## Service Bulletin

**02-158**

Flush Mount Battery Box Washer Wear

8/25/2020

**Figure 1**

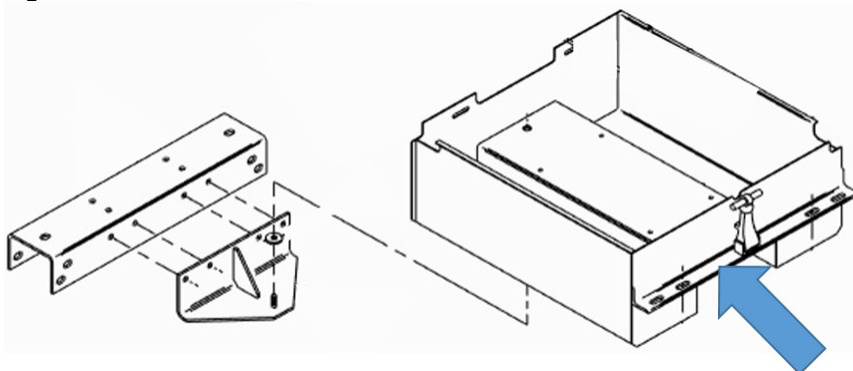
1. Determine how many reinforcement brackets are required based on the box type. Each mounting angle requires a reinforcement bracket. The example shown in Figure 1 has only one mounting angle.

**Figure 2**

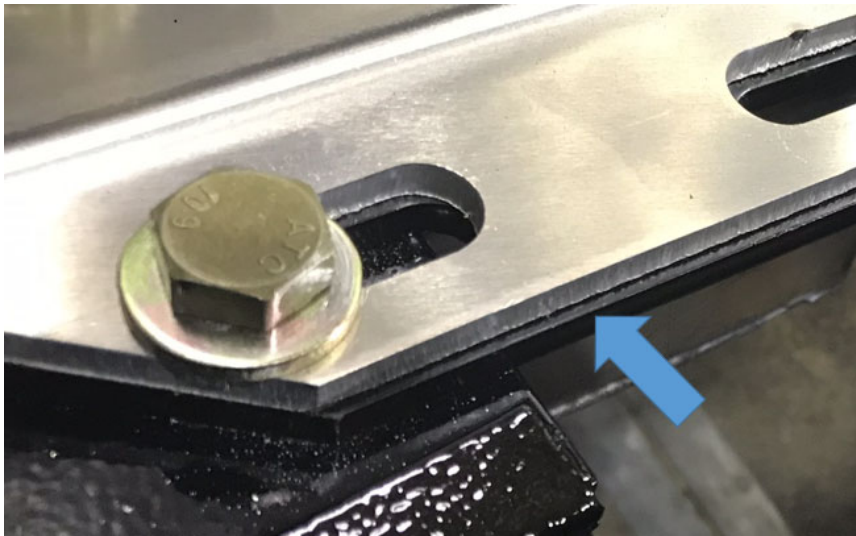
2. Remove the lid and disconnect the negative battery cable coming from the chassis. If there is not enough slack to lift the box, additional cables may need to be disconnected.
3. Remove the bolts that attach the box to the frame brackets. The hardware will not be reused.
4. Carefully lift the box approximately 1 inch above the frame brackets. A hoist or a jack with blocks may be used.
5. Place the reinforcement bracket(s) between the box mounting angle(s) and the frame-mounted brackets as shown in Figure 2.
